Re: Low Flow Air Sparge Work Plan Addendum Former Signal Oil Station (Chevron Site 20-6145) 800 Center Street Oakland, California Fuel Leak Case No. RO0454

Conestoga-Rovers & Associates (CRA) is submitting this *Low Flow Air Sparge (LFAS) Work Plan Addendum* (Addendum) on behalf of Chevron Environmental Management Company (Chevron) for the site referenced above. In a letter dated October 16, 2009 (Appendix A), Alameda County Environmental Health (ACEH) concurred with the proposed implementation of the LFAS pilot test, but listed three technical comments to be addressed and requested clarification of the construction timing. Summarized below are responses to ACEH's technical comments.

Subject: Incomplete Human Health Risk Assessment, Rejection of Revised CAP, and Approval of LFAS Workplan – Fuel Leak Case No. RO0000454 (Global ID # T0600102230), Chevron #20-6145/Signal SS, 800 Center Street, Oakland CA 94607

FIGURE 1

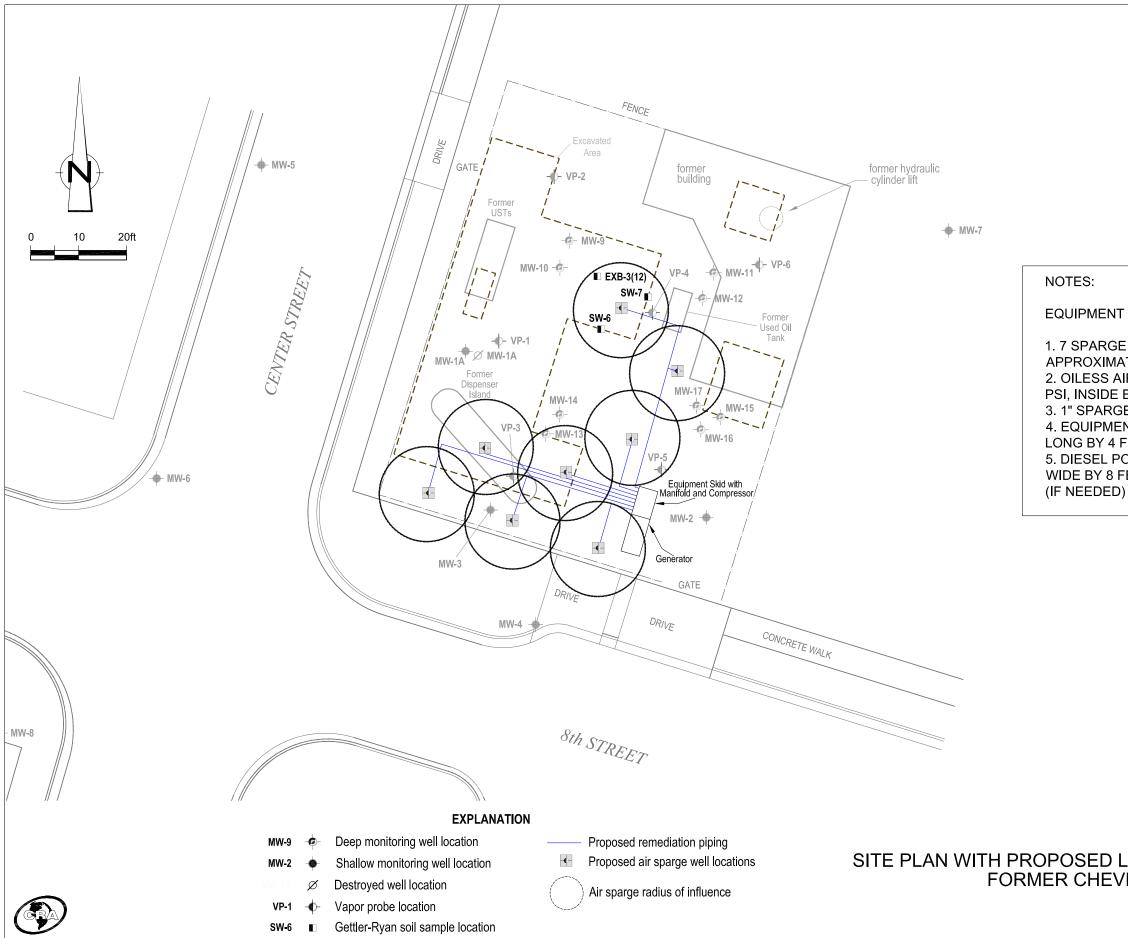
- c) Additional benefit may be derived by the installation of an additional LFAS point in the vicinity of soil samples EXB-3 (12), SW-6, and SW-7 due to elevated residual soil concentrations and a position upgradient of well MW-1A. Residual soil concentrations in this vicinity are likely contributory to the groundwater plume located further downgradient at the site as indicated by groundwater samples collected from wells MW-1A, MW-13, and MW-14, but which do not appear to contribute to soil vapor concentrations detected at VP-4.

One additional LFAS point will be installed in the vicinity of soil samples EXB-3 (12), SW-6, and SW-7 to address residual hydrocarbon impacts in this area. Figure 1 presents the revised site plan with proposed LFAS point locations. All LFAS points will be installed and constructed as proposed in CRA's April 27, 2009 *Work Plan for Low Flow Air Sparging Pilot Test and Additional Soil Vapor Sampling*.
